UNITED STATES PATENT AND TRADEMARK OFFICE

APPLICATION NO.	FILING DATE	FIRST NAMED INVENTOR	ATTORNEY DOCKET NO.	CONFIRMATION NO.
09/808,818	03/15/2001	Ryuichi Murai	NAK1-BO22	5636

Office Action Summary

DETAILED ACTION

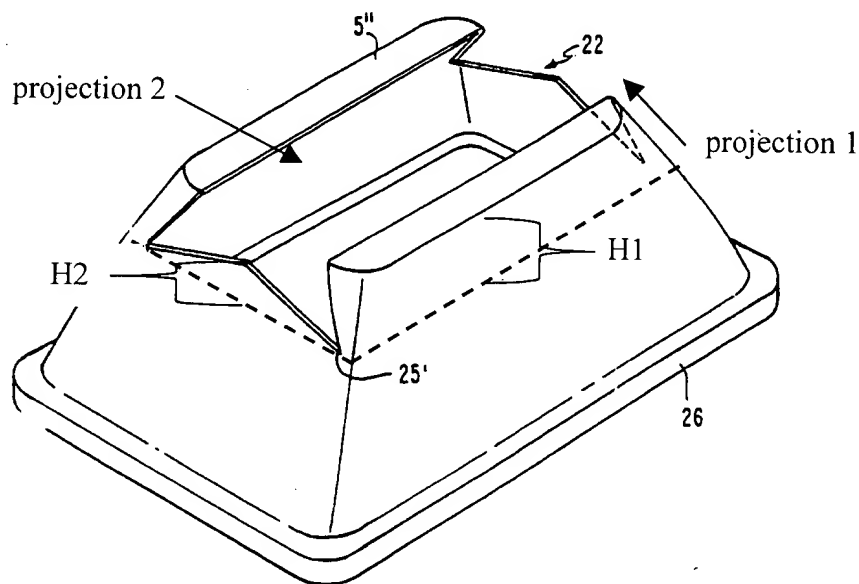
19. Claims 1-7, and 10 are rejected under 35 U.S.C. 103(a) as being unpatentable over Van Mensvoort (USPN 5,363,010).
20. In regards to claims 1-7, Van Mensvoort discloses in figure 8, a CRT comprising a beam trajectory deflection means (5) which deflects an electron beam in a direction opposite to an electron beam deviation, and further that an equivalent height H1 is greater than an equivalent height H2 (see below).

22. However, one of ordinary skill in the art can see that Van Mensvoort's shield comprises a magnetic flux which proceeds in a general direction of a tube axis, and further, that the shield has $R1 > R2$, $B1 > \phi 2$, $R1 > R2$, and $R1_{center} > R2_{edge}$, and these properties are inherent to the shape and structure of the shield.

24. In regards to claim 10, Van Mensvoort discloses in figure 8, a CRT comprising a pyramidal-shaped internal magnetic shield (5) having an extension (5'') at a center of both horizontal long sides of the shield, and the extension is higher than both short sides (25) of the shield. Van Mensvoort further discloses in figure 1, the CRT includes a mask (8).
